**STATE OF CALIFORNIA
REGIONAL WATER QUALITY CONTROL BOARD
CENTRAL COAST REGION**

STAFF REPORT FOR REGULAR MEETING OF NOVEMBER 13-14, 2014

SUBJECT: Order No. R3-2014-0046, Revision of Waste Discharge Requirements for California Army National Guard - Camp Roberts Training Facility, San Luis Obispo and Monterey Counties

Figure 1 - Existing and Proposed Schematic

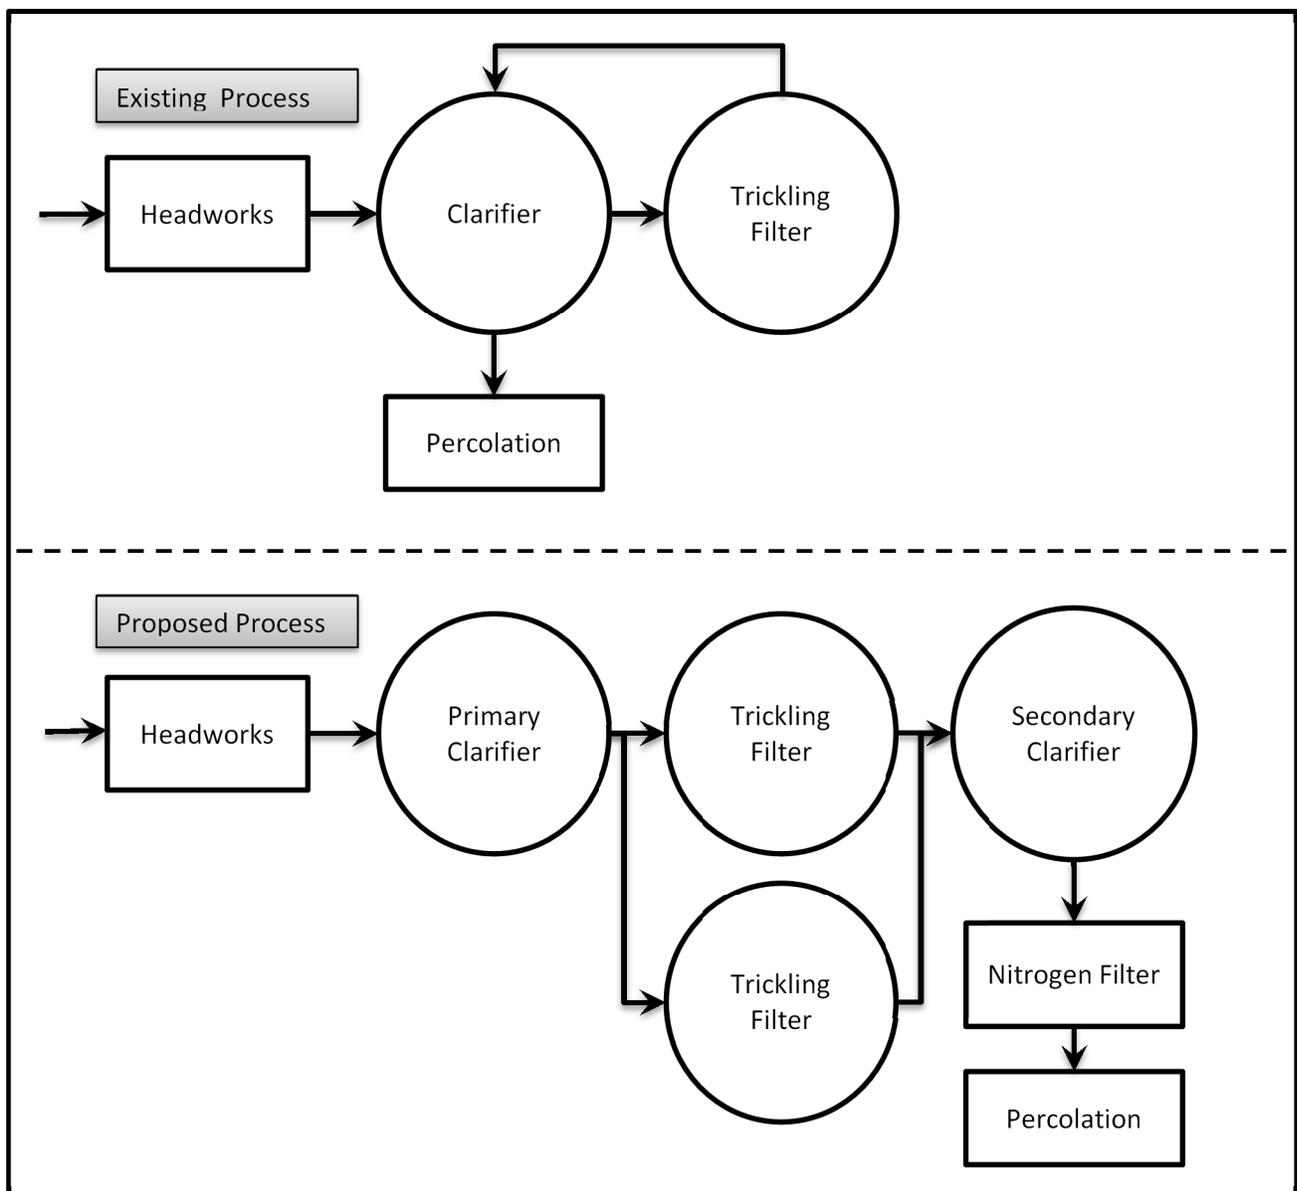
The improvements will refurbish an abandoned clarifier and trickling filter, as well as alter plumbing to achieve true secondary clarification. The upgrade to the existing Main Garrison wastewater treatment and discharge facilities is represented by the following schematic:

As shown and mentioned above, a key improvement is separation of primary and secondary clarification stages to eliminate discharge of partially treated wastewater and improve overall effluent quality with respect to BOD and suspended solids. Another key improvement is the addition of a denitrifying filter to reduce effluent nitrogen concentrations. The proposed first phase of installing denitrification treatment would provide nitrate treatment capacity for an average daily flow of 0.04 MGD. Additional filter capacity would be required in the future when the Camp Roberts population increases.
